MONITORING YEAR 0 ANNUAL REPORT FINAL

LAUREL VALLEY MITIGATION SITE

SUBJECT: NCIRT Review and USACE Approval of the NCDMS Laurel Valley Mitigation Plan Addendum / Burke County/ SAW-2020-00053/ NCDMS Project # 100140

RE: Notice of Mitigation Plan Addendum Approval & Initial Credit Release
Laurel Valley Mitigation Site – Burke County
Catawba River Basin Cataloging Unit 03050101
DMS Project ID #100140
USACE ACTION ID SAW-2020-00053
DWR # 20200018

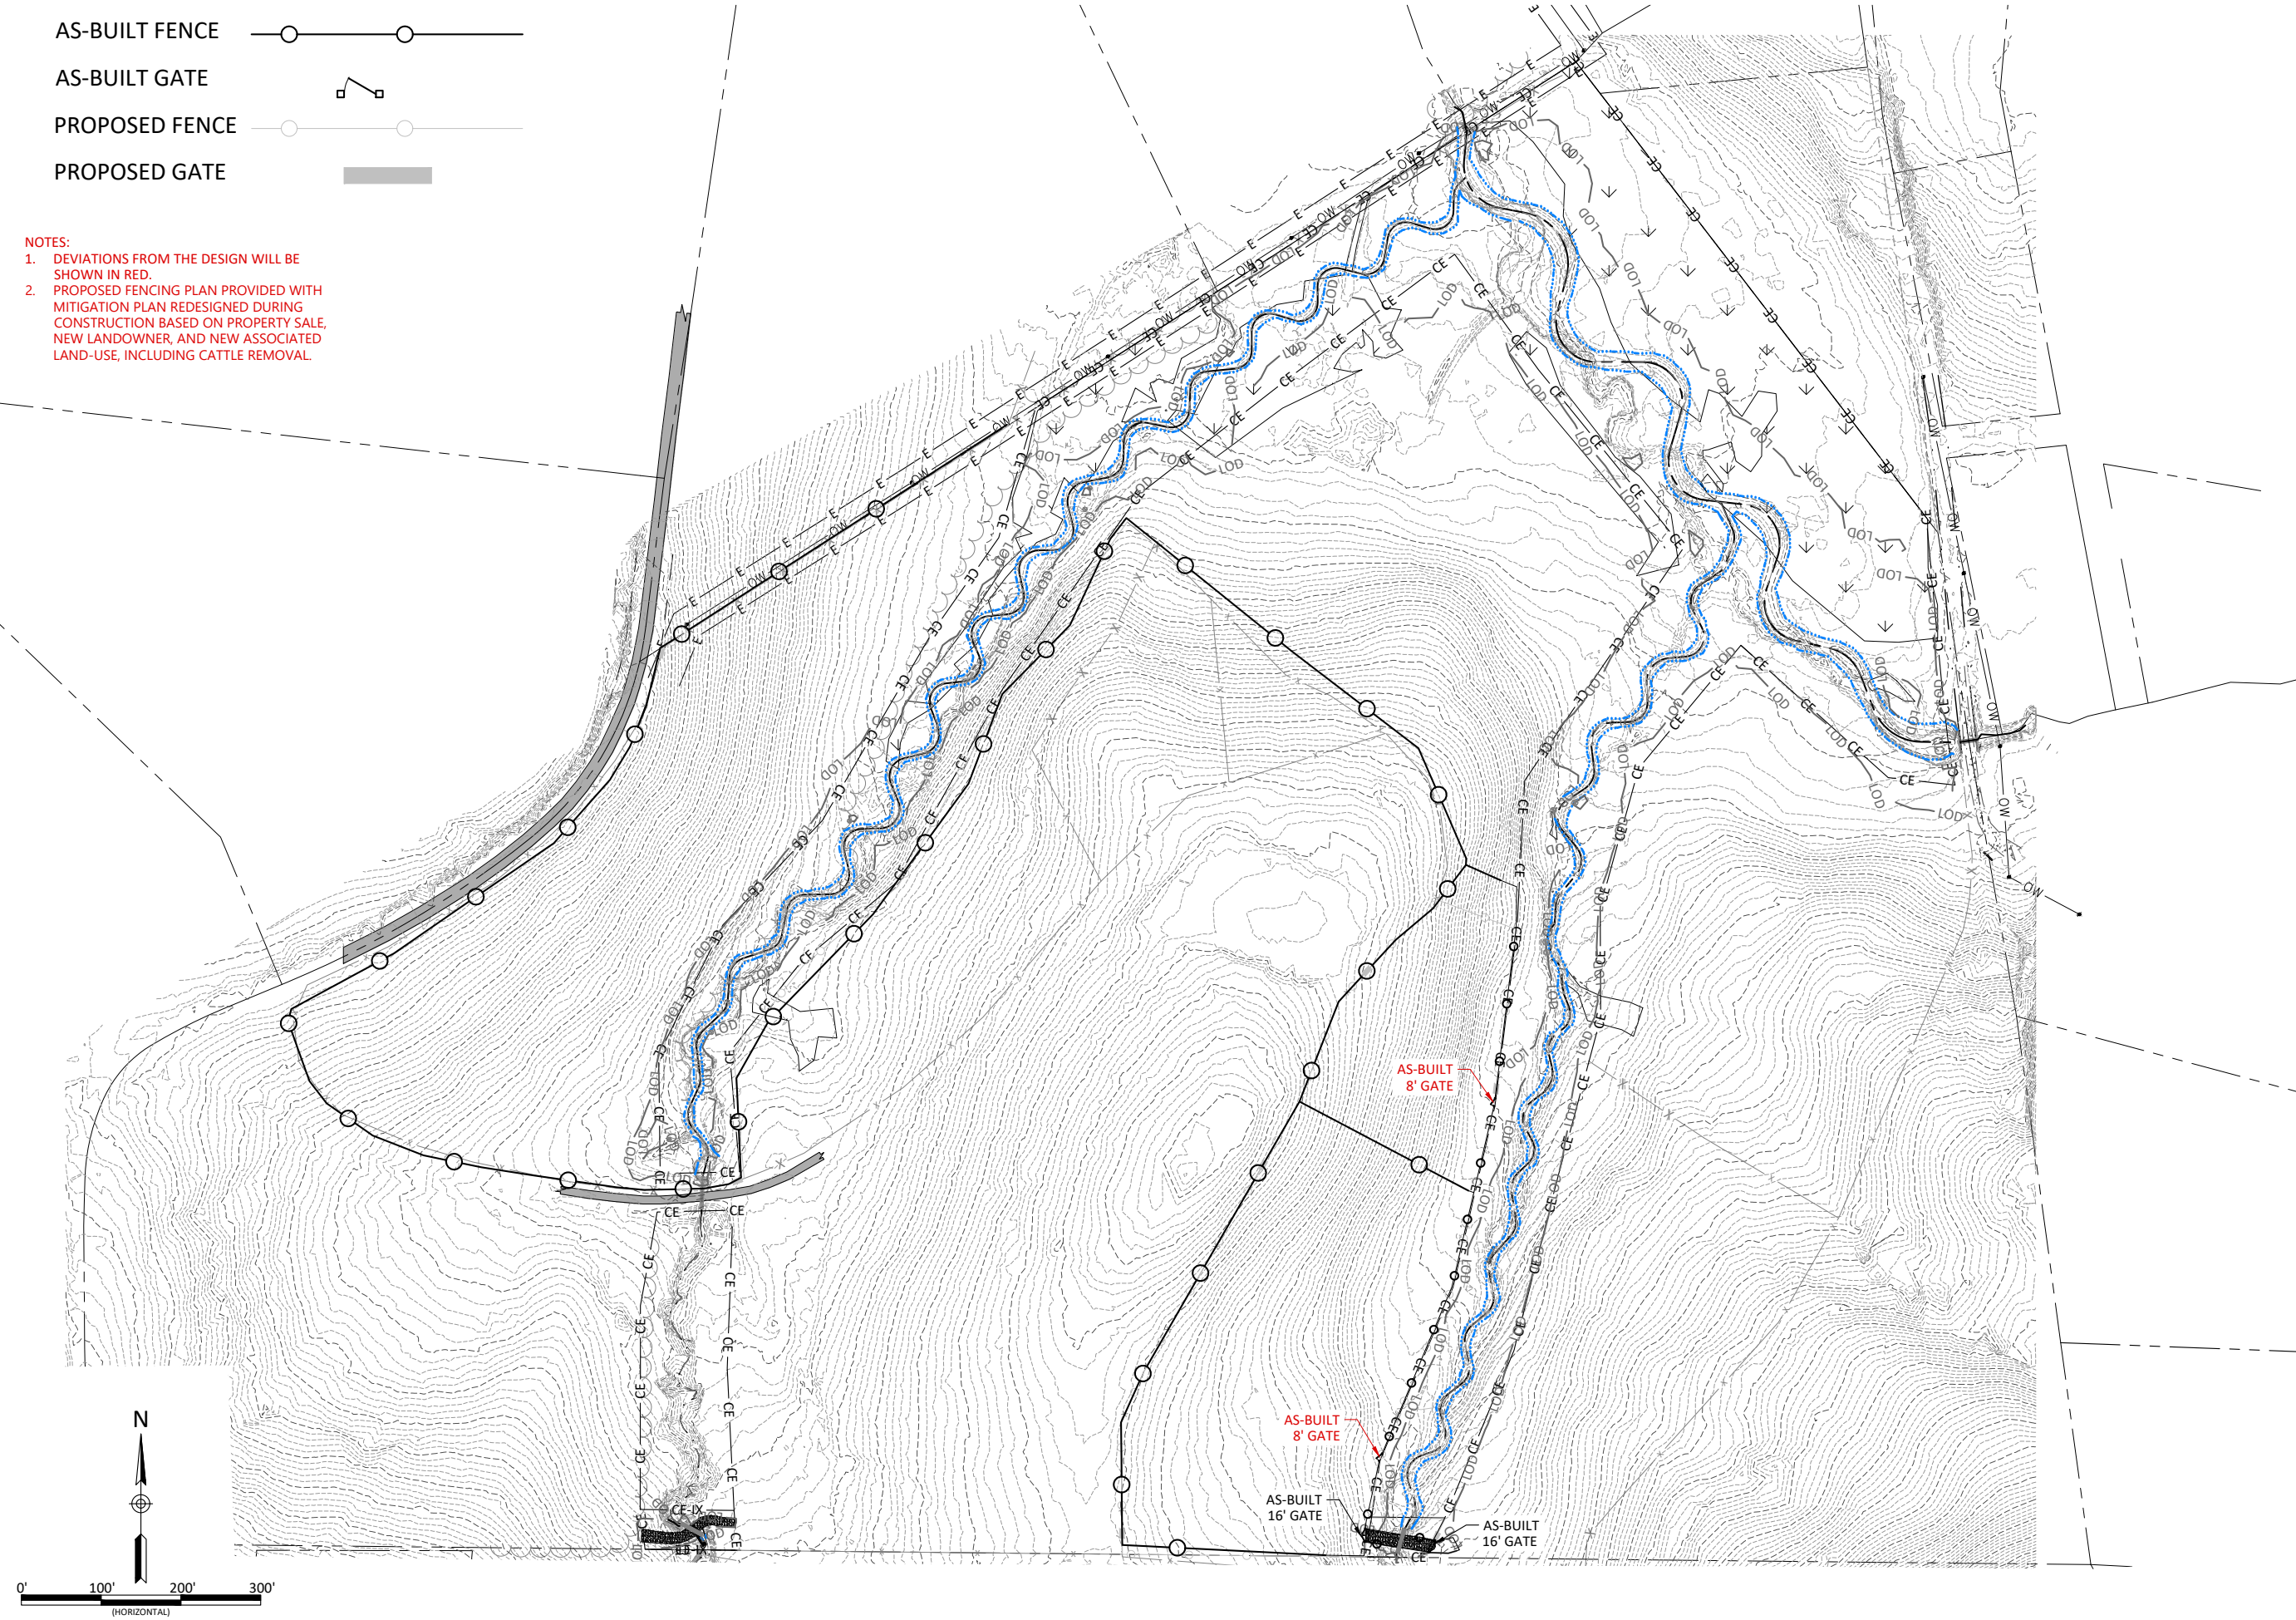
6. *Section 2.1.7 Fencing Plan – Since recent land use removing cattle from project pasture areas has dictated changes in the fencing needs (i.e., removal) for the project, can Wildlands briefly discuss what land use changes are expected in the near term (hay, agriculture, etc.) and how Wildlands plans to adjust their monitoring approach to ensuring the integrity of the easement? Assuming these fields will be mowed or maintained in some way, without fencing, there is a legitimate risk of scalloping. Does Wildlands plan to add any signage or non-livestock boundary fencing in these areas? If mowing or other encroachments occur, how does Wildlands plan to remedy this? Please discuss in this section and clarify.*

Wildlands Response: Language was added to Section 2.1.7 to address the change in agricultural land use at the Site, potential encroachments, and potential remediation as necessary.
